### Camp Lejeune MET Site

### MCAS New River MET Site

**COMBINATION MNS & FIRE ALARM RISER DIAGRAM**  
 NO SCALE

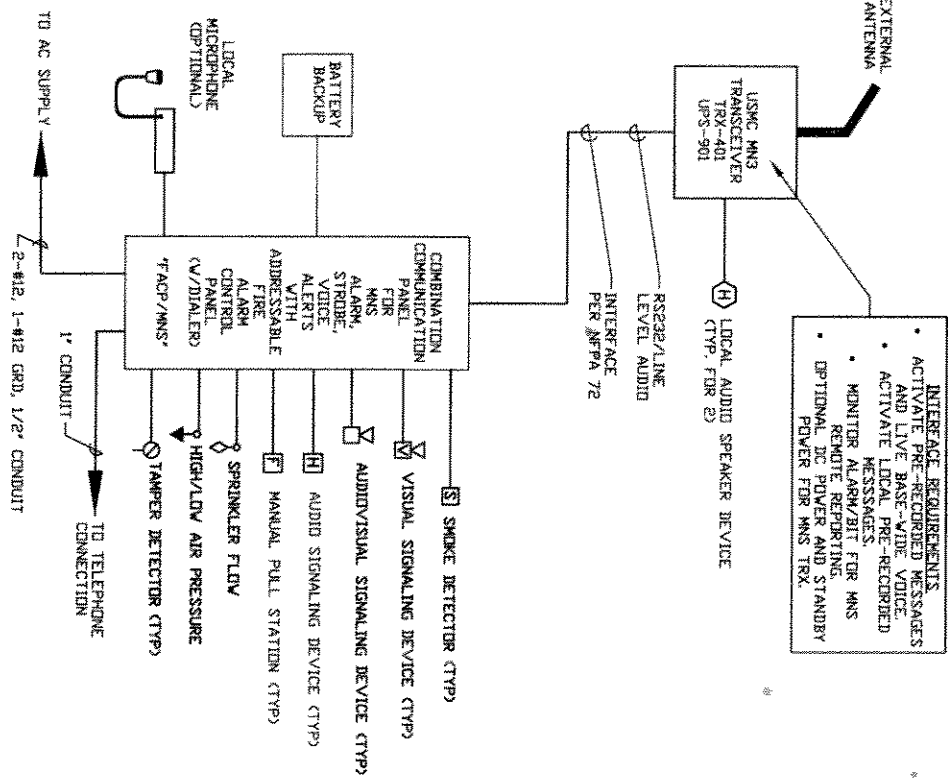
Sheet A-1, Provide new addressable fire alarm system with dialer next to door A101. See attached riser diagram schematic. Disregard sprinkler system connections. USMC MN3 Transceiver shall be provided by others, ensure connections are provided at the FACP. Provide pull stations at each egress point. Provide 4 (four) smoke detectors installed above each trainer.

Sheet A-4, Provide new addressable fire alarm system with dialer next to door A102. See attached riser diagram schematic. Disregard sprinkler system connections. USMC MN3 Transceiver shall be provided by others, ensure connections are provided at the FACP. Provide pull stations at each egress point. Provide 4 (four) smoke detectors installed above each trainer.
